## **LAKESIDE COMMERCIAL PARK WEST SUBDIVISION** **RESUBDIVISION OF LOTS 2 AND 3**

APPLICATION NUMBER 27 DATE March 6, 2008

REQUEST Subdivision

# DETAIL SITE PLAN

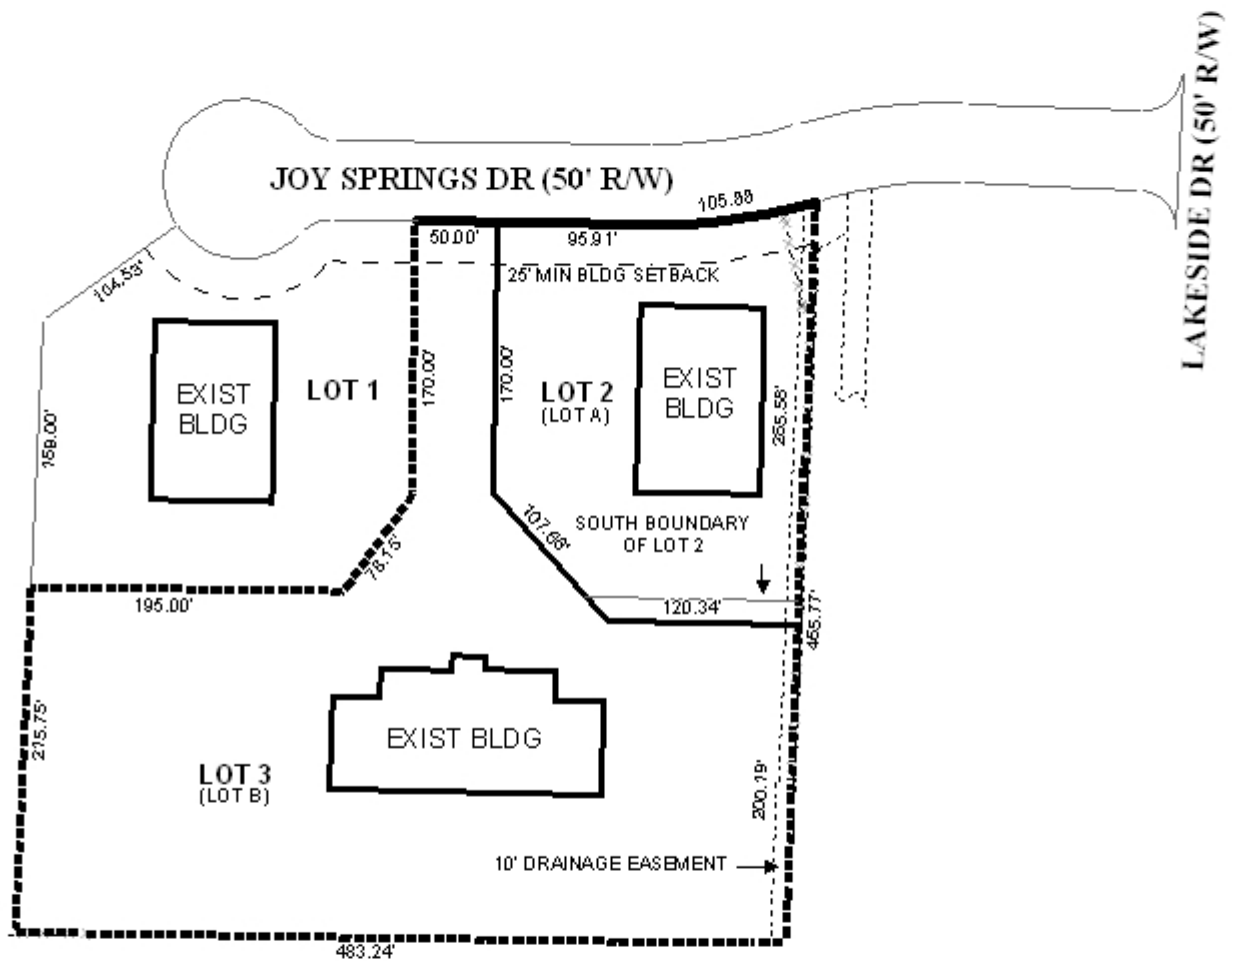
Lakeside Commercial Park West Subdivision was recorded in 1999. Along with the subdivision, an Administrative Planned Unit Development was approved for multiple buildings on a single building site, and an amendment would be required to move an interior lot line. However, upon review of the site, it appears that Lots 1, 2, and 3 of Lakeside Commercial Park West Subdivision have shared access via a private drive, which is part of Lot 3. No Planned Unit Development is on file for this shared access; thus, one will be required.

As proposed, Lots A and B have approximately 300 and 50' of frontage along Joy Springs Drive. However, access to these lots is via a driveway that is part of the existing Lot 3. If approved, a note should be placed on the final plat stating that the site is limited to the existing curb cuts to the shared private drive.

Based on the preceding, it is recommended that this application be held over until the April 3<sup>rd</sup> meeting to allow the applicant to submit a Planned Unit Development application for the shared access among adjacent building sites.
